Town of Hilton Head Island
Design Review Board Meeting
Tuesday October 10, 2023 – 2:30 P.M.
AGENDA

Response from comments from Conceptual Review for the New Serg Brewery/Car Storage at 1014 William Hilton Parkway

FINAL DRB SET
 A RENOVATION FOR A NEW BREWERY/
 CAR STORAGE AT:
1014 WILLIAM HILTON PKWY
 HILTON HEAD ISLAND, S.C.

KALWALL WALL SECTION 1
SCALE: 1" = 1'-0" A.3.2

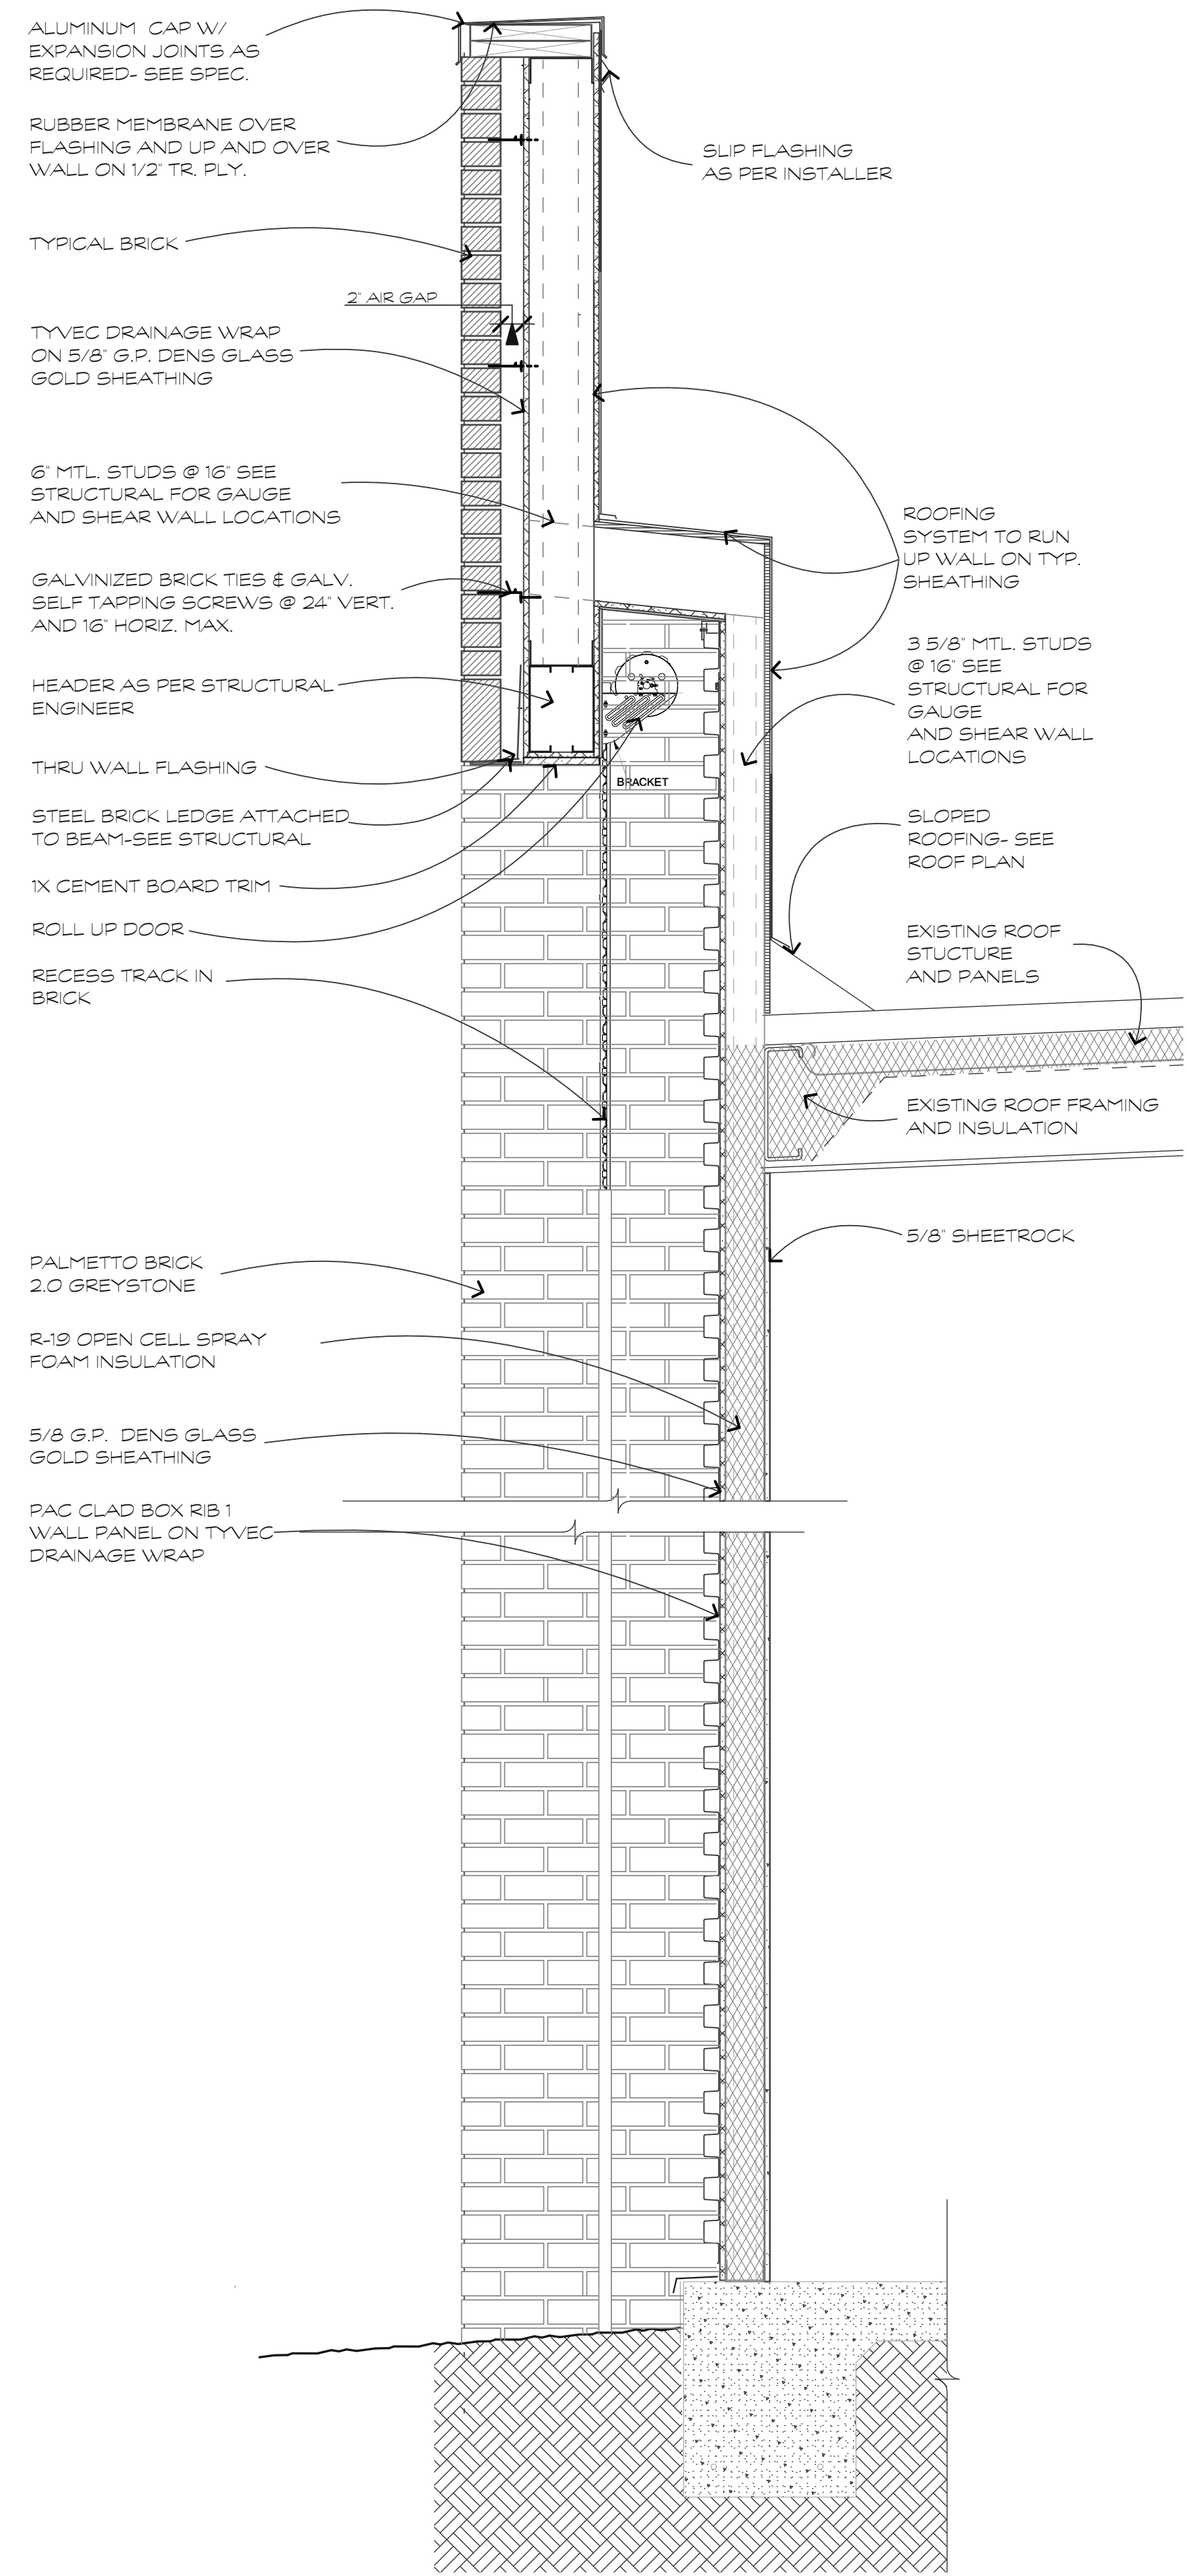
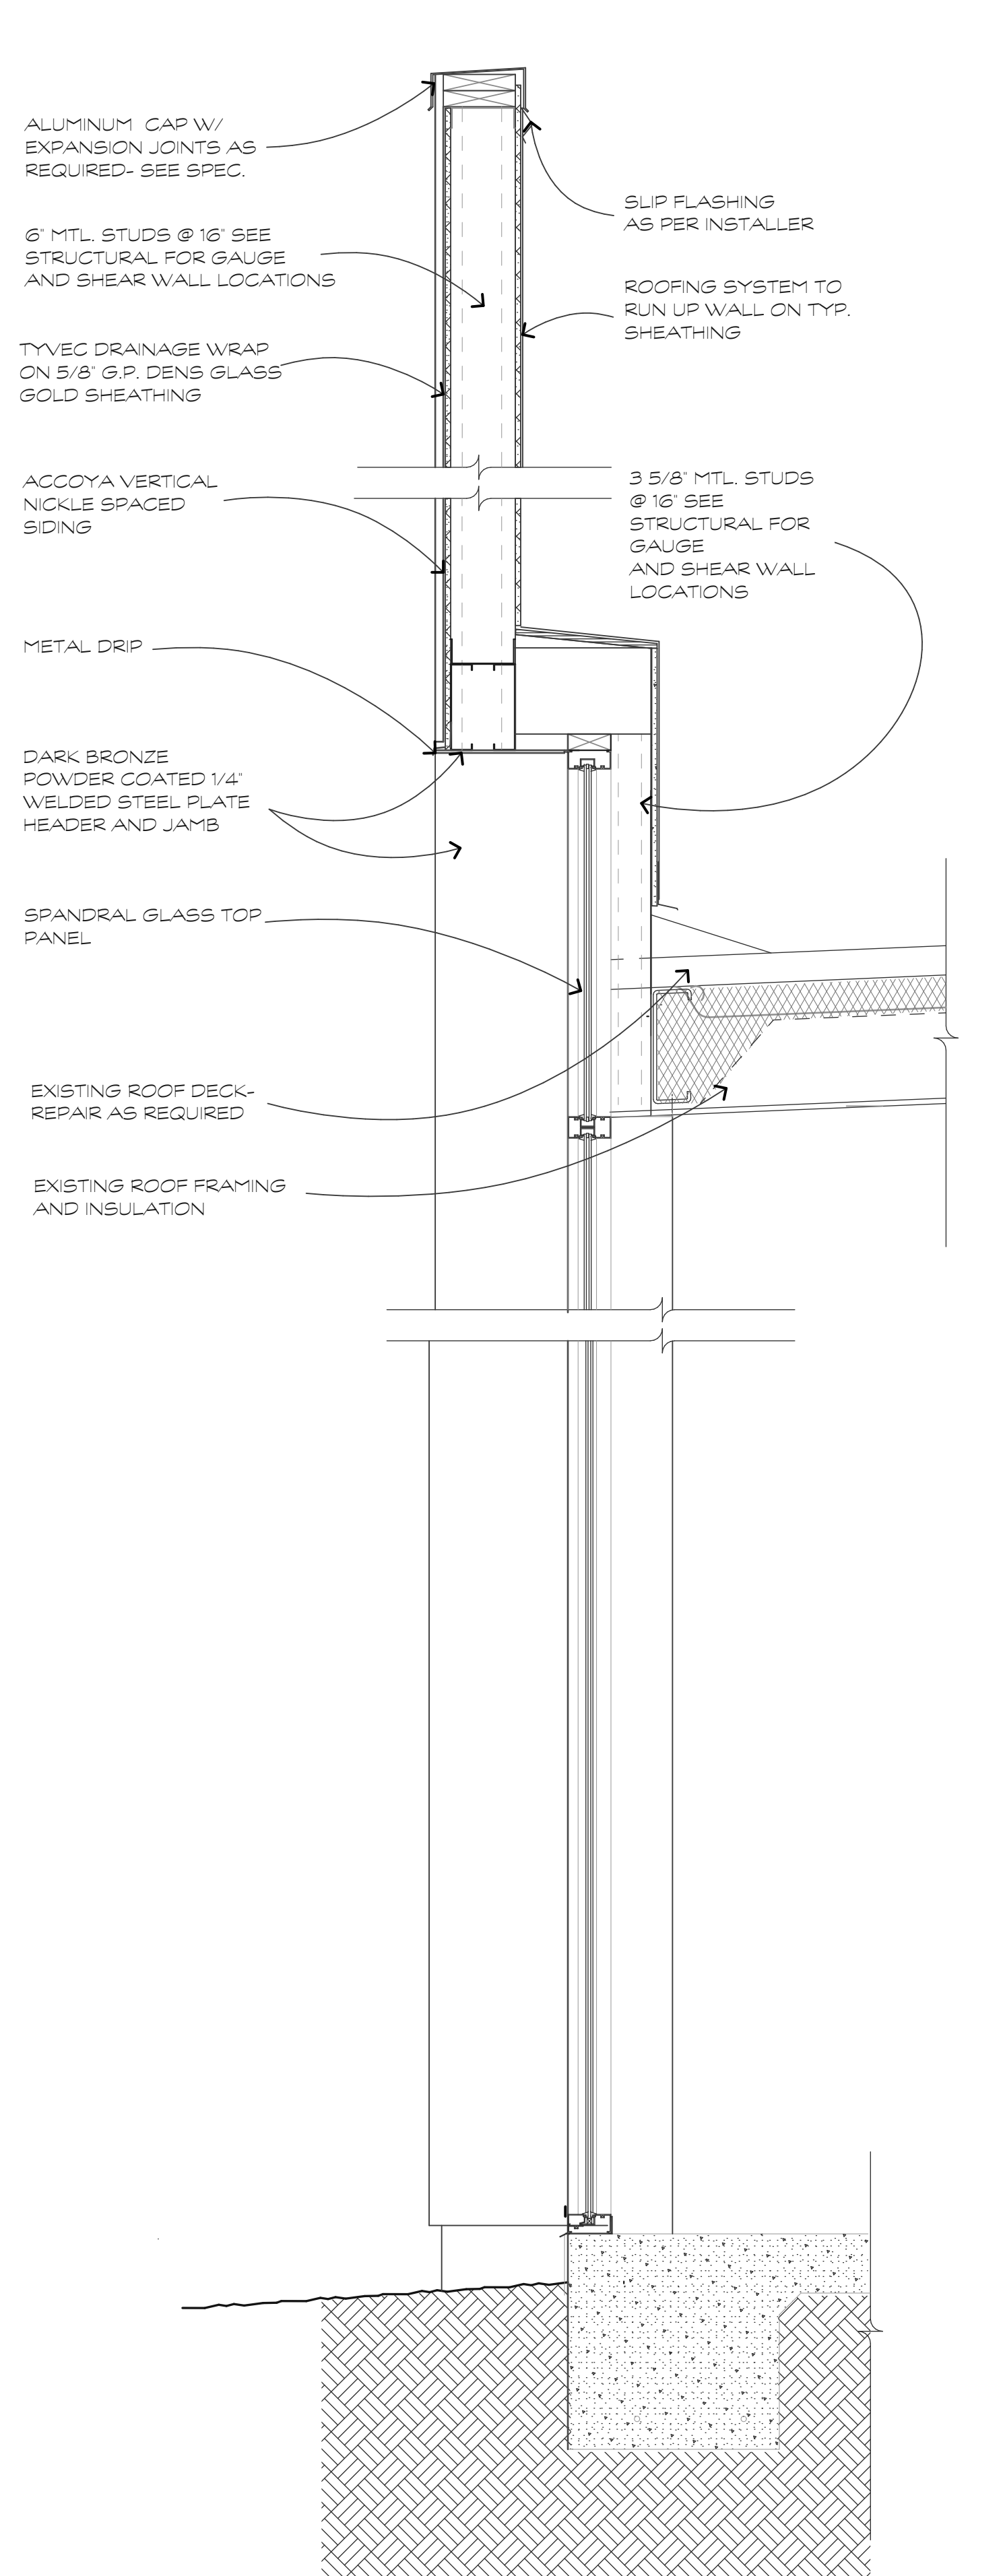
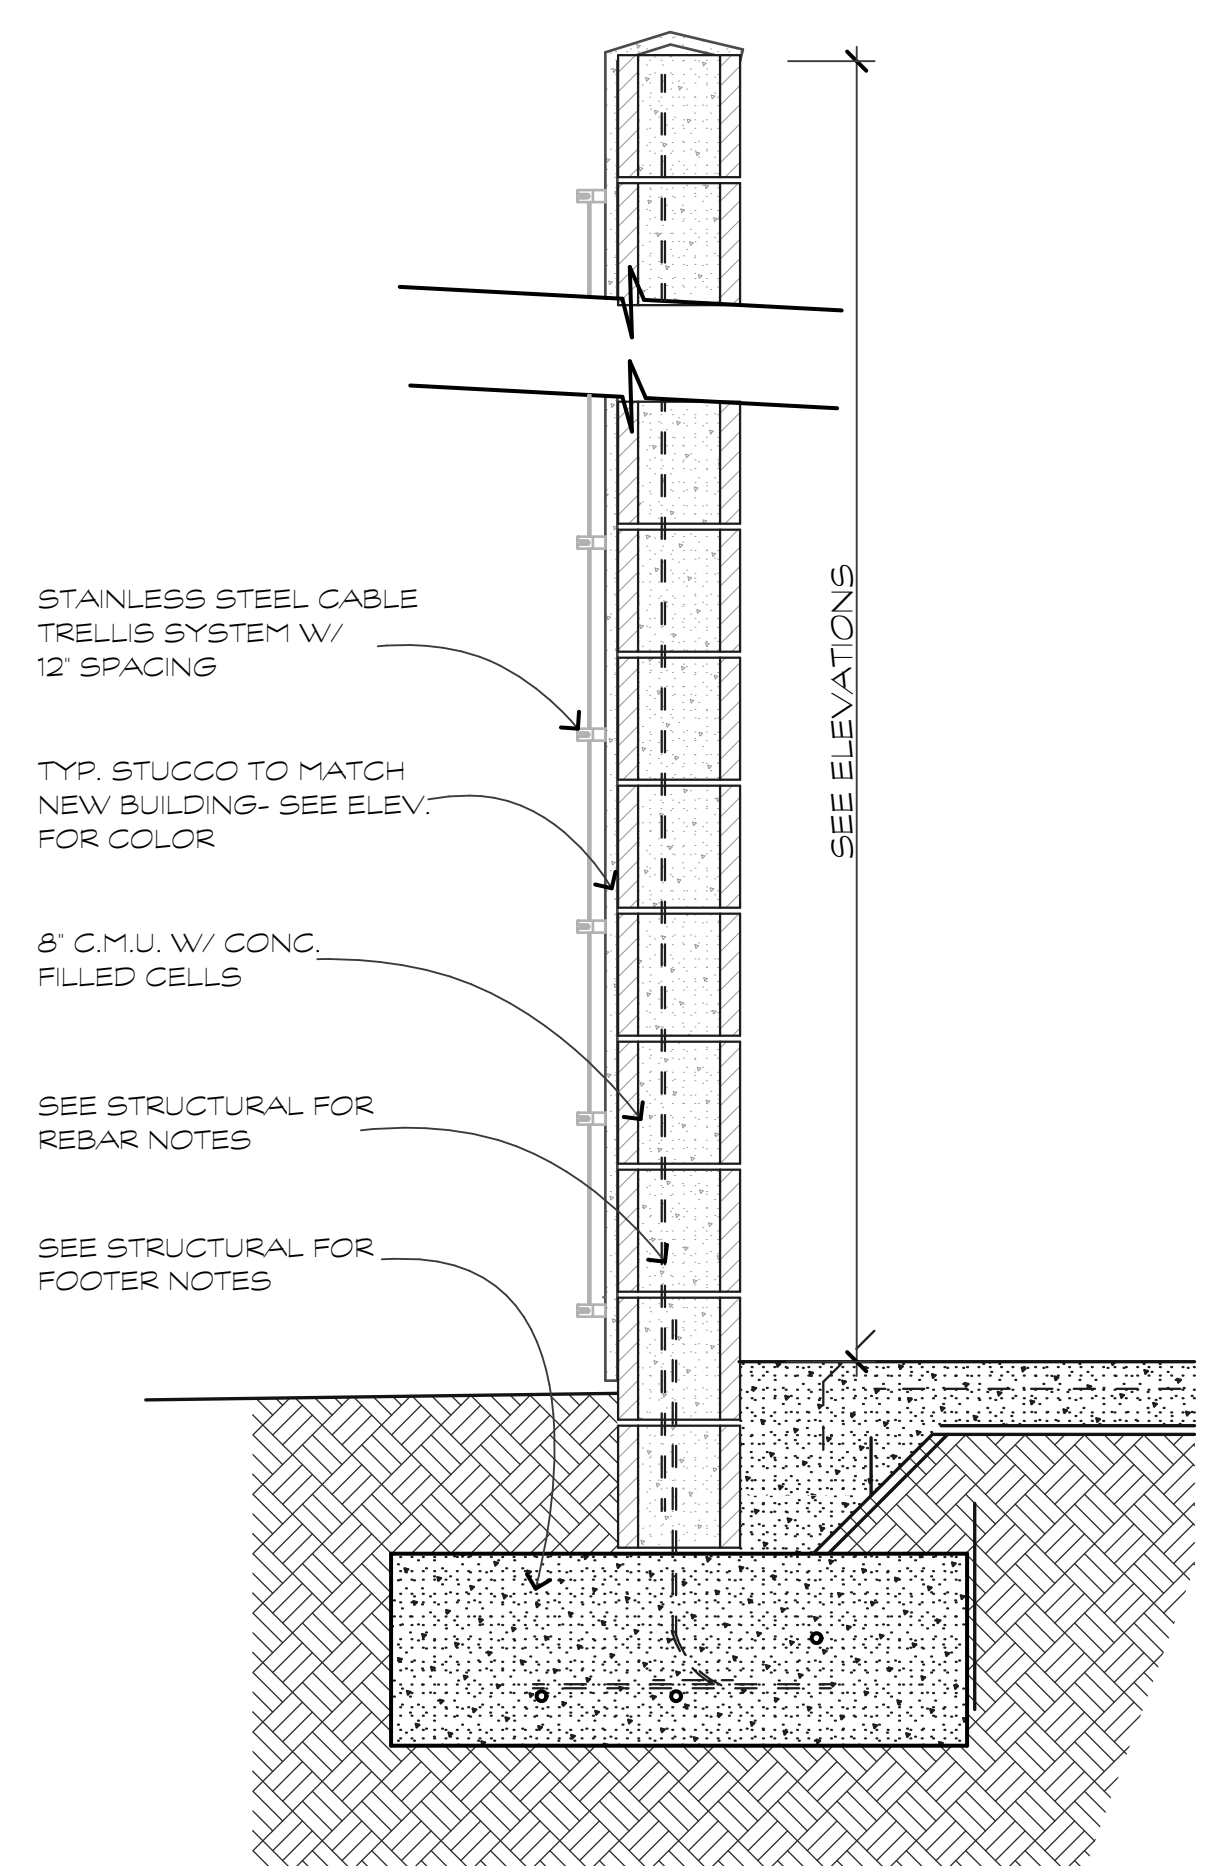
1. Correct the left and right color visual titles on the plan. ***We have corrected the left and right color visual titles on the color elevations.***
2. Add wall sections where appropriate to show dimension and scale. ***We have added wall sections to the final DRB set. See sheets A.3.1 and A.3.2.***

DRAWING NUMBER
L100

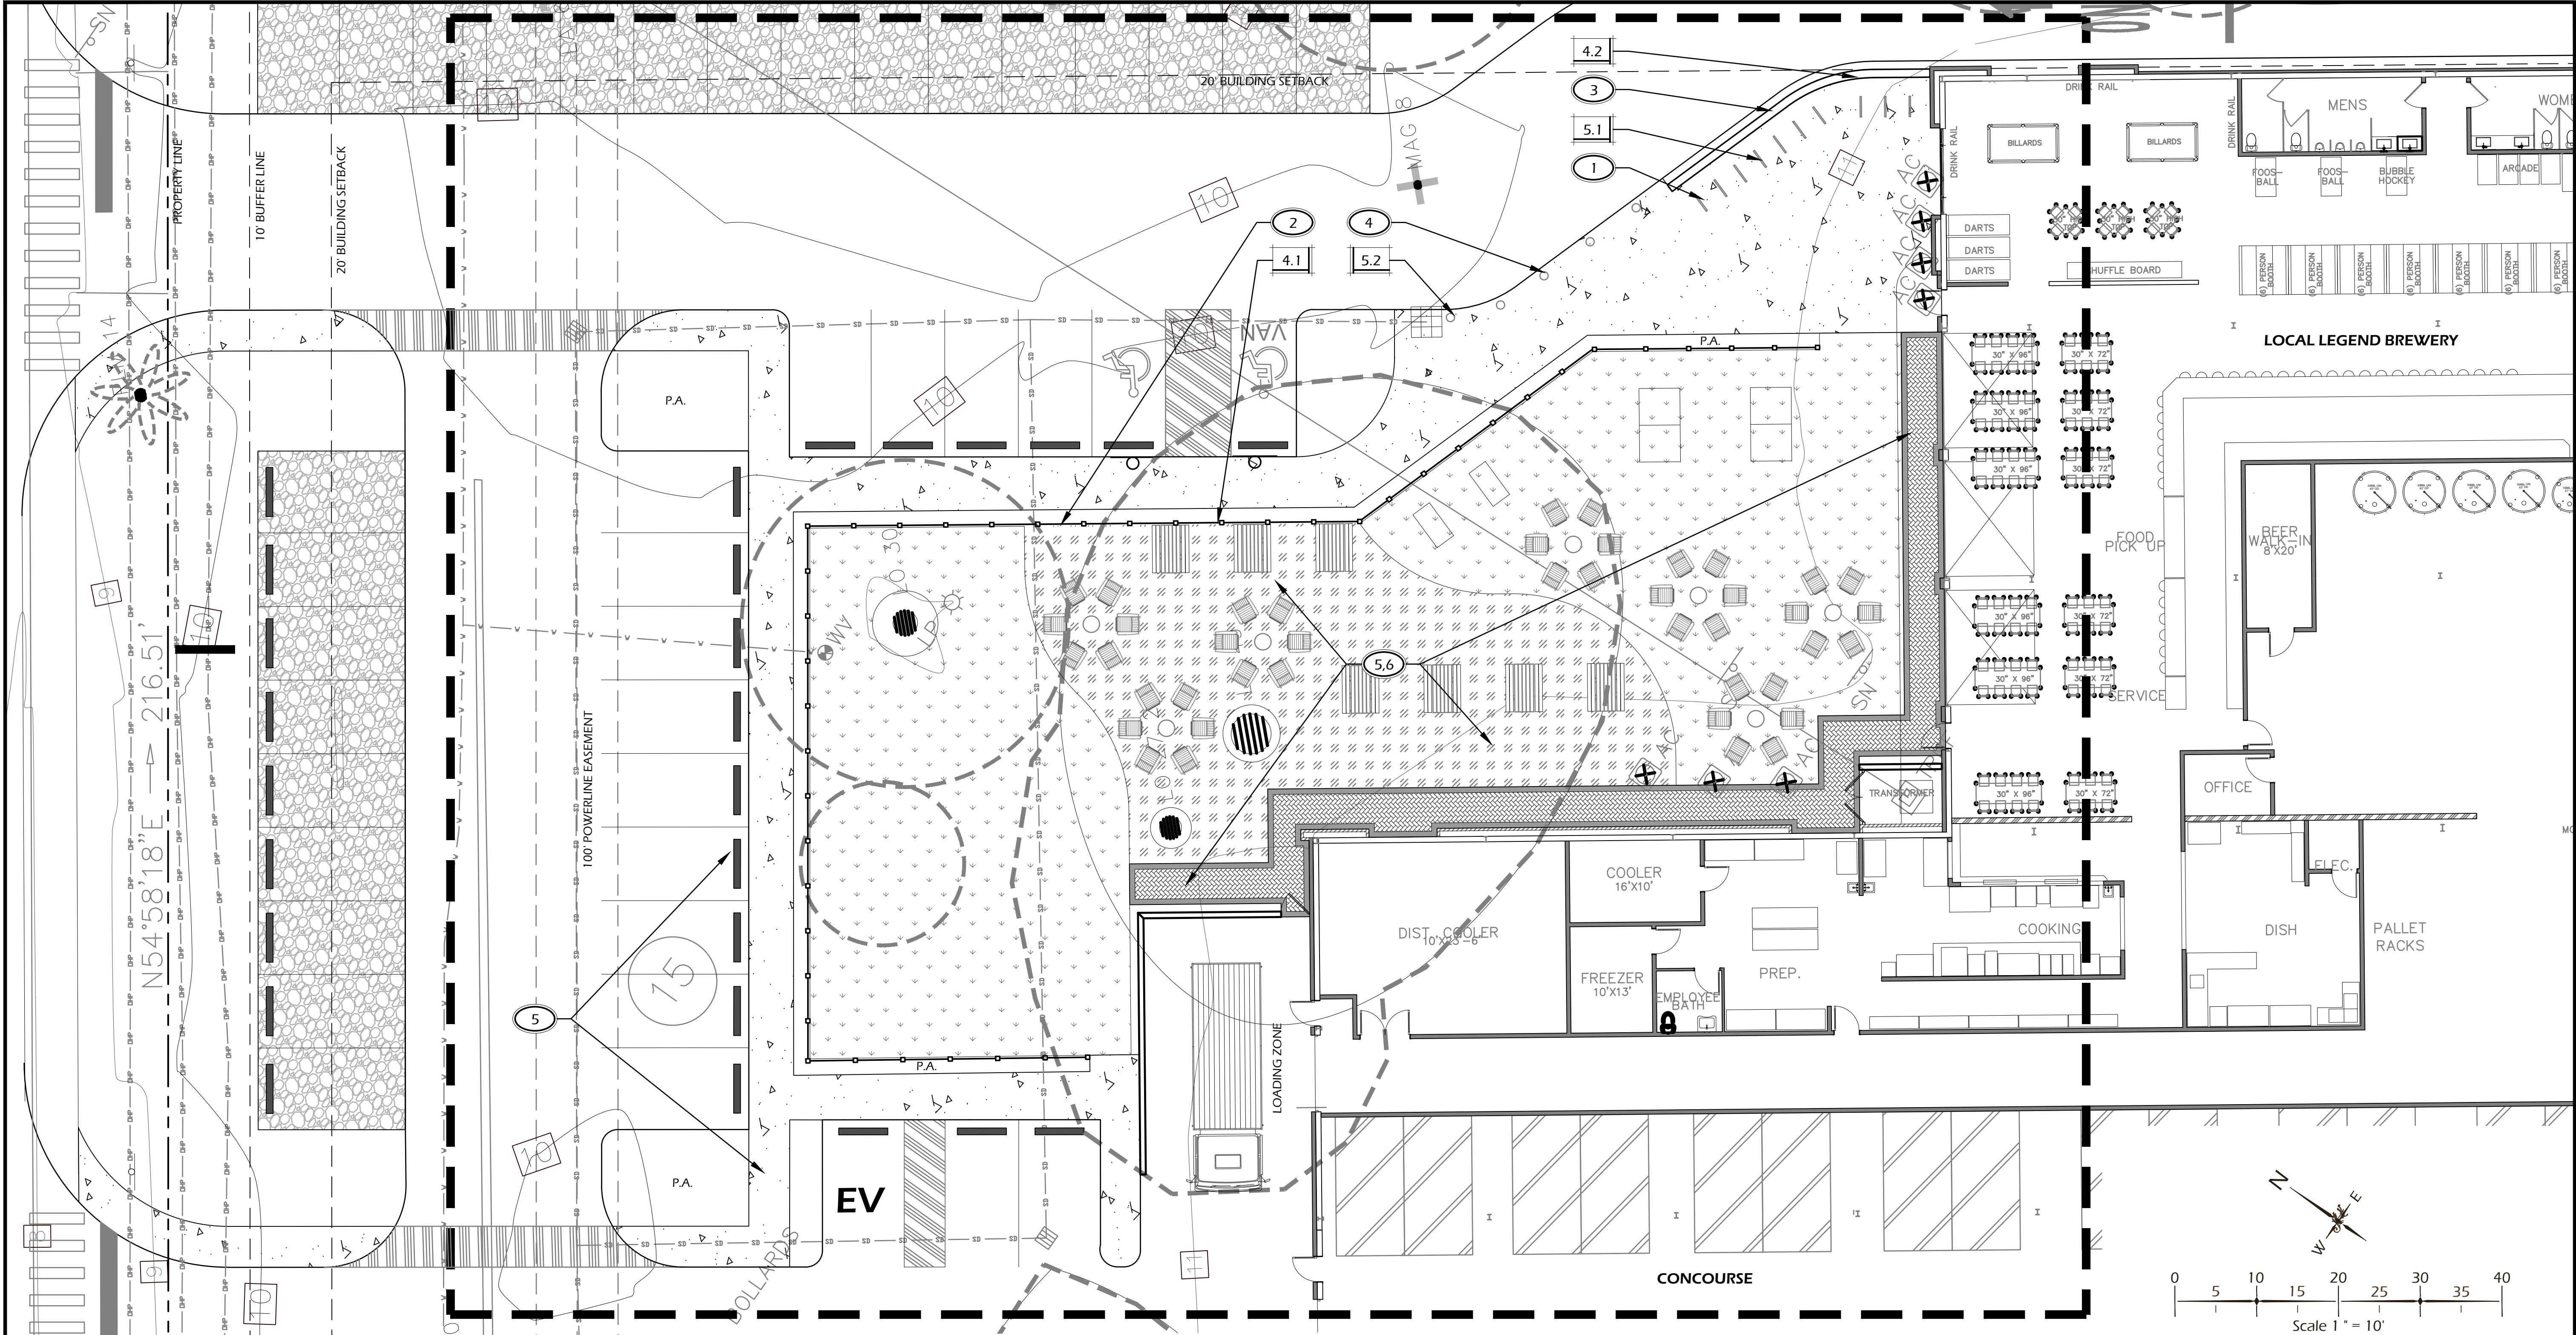
- L50 – No change
- L100 – Sign locations called out
 - Add wheelstops at front parking
 - Dumpster Enclosure callout and detail reference
 - Utility Enclosure callout and detail reference
